CONSIDER AND TAKE APPROPRIATE ACTION ON THE REQUEST TO APPROVE CHANGE ORDER NUMBER ONE (1) ON SEALED PROPOSAL 181610 ON AUSTIN CENTER PARKING LOT AS PER BOARD POLICY CV, AND STATE GUIDELINES.

Subject: **Change order number 1 on Sealed Proposal 181610 on Austin Center Parking Lot**

Re: **Austin Center Parking Lot Addition**
Proposed Change Order #1 Recommendation

SHEET:
D1

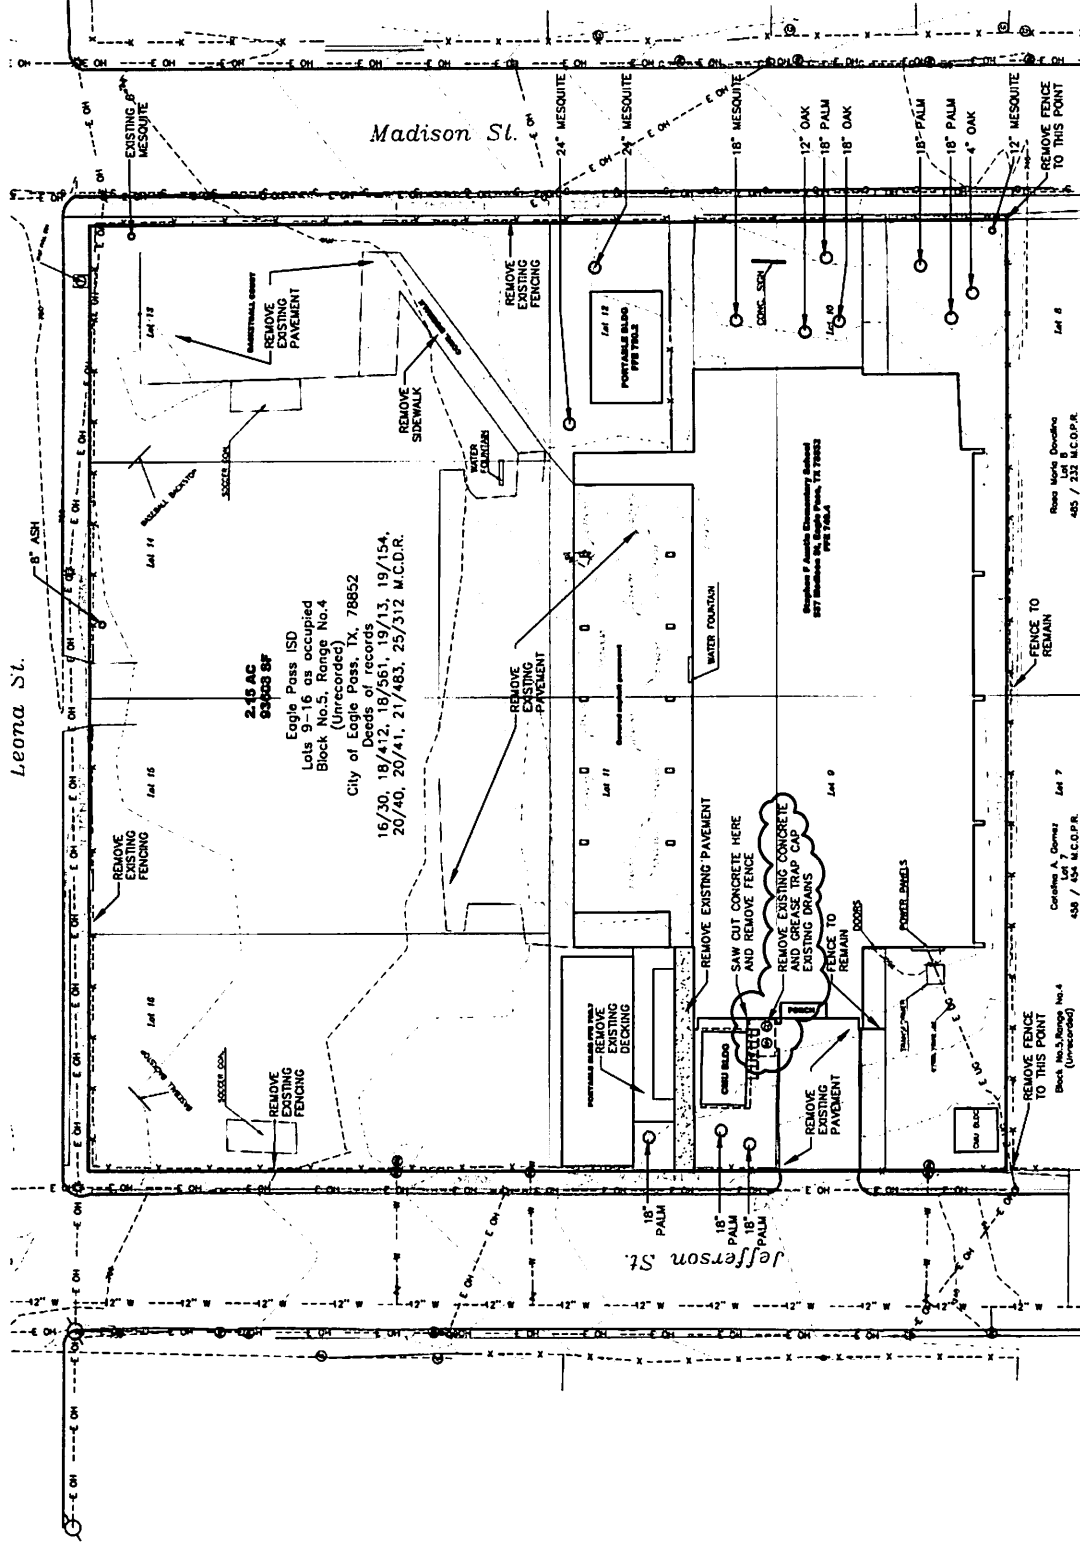
1. Add new metal roofing to existing storage building on Madison Street.
2. Install roofing per details on attachment of this PR.
